## **23 RESPONSE TO COMMENTS ON THE DEIR/EIS**

### **23.1 INTRODUCTION**

This document is a Final Environmental Impact Report and Environmental Impact Statement (FEIR/EIS) prepared on behalf of Placer County and the Tahoe Regional Planning Agency (TRPA) pursuant to the California Environmental Quality Act (CEQA) and the Tahoe Regional Planning Compact and the TRPA Code of Ordinances. On January 21, 2011, Placer County and TRPA distributed to public agencies and the general public a Draft Environmental Impact Report and Environmental Impact Statement (DEIR/EIS) for the Homewood Mountain Resort Ski Area Master Plan Community Enhancement Program Project (Project).

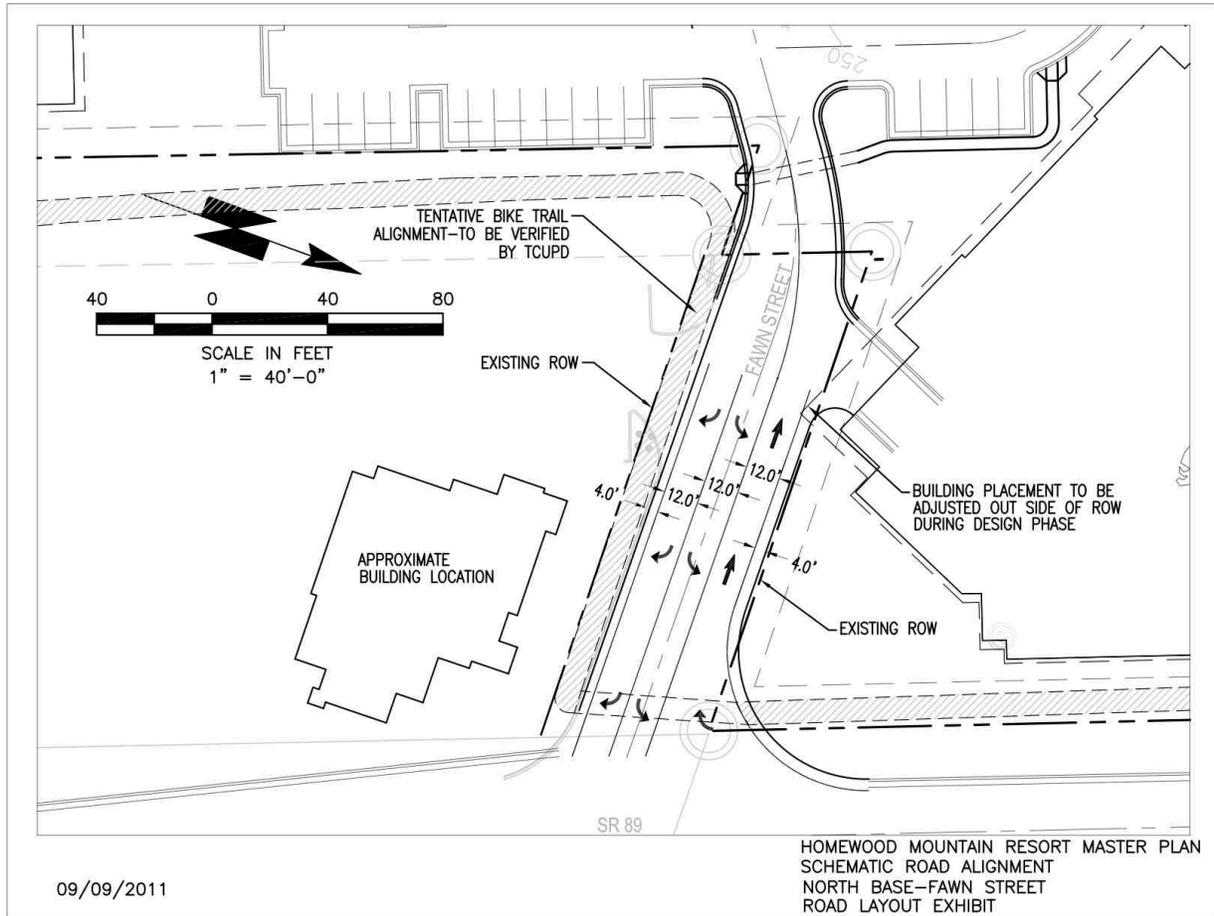
Comment 3-4 *Comment Summary – P. 11-104, recommend adding a right-turn only lane on Fawn Street in addition to left turn only lane.*

Comment noted. The cumulative condition mitigation measure recommended for the SR 89/Fawn Street intersection in the DEIR/EIS requires an exclusive right-turn pocket. The resulting lane configuration would include a shared through/left-turn lane and a right-turn pocket. The eastbound through volume at this intersection is 0, therefore, the eastbound approach will operate as a left-turn lane and right-turn pocket. To demonstrate that there is adequate room to accommodate the

recommended mitigation measure, please see the roadway configuration developed by HMR civil engineers below:
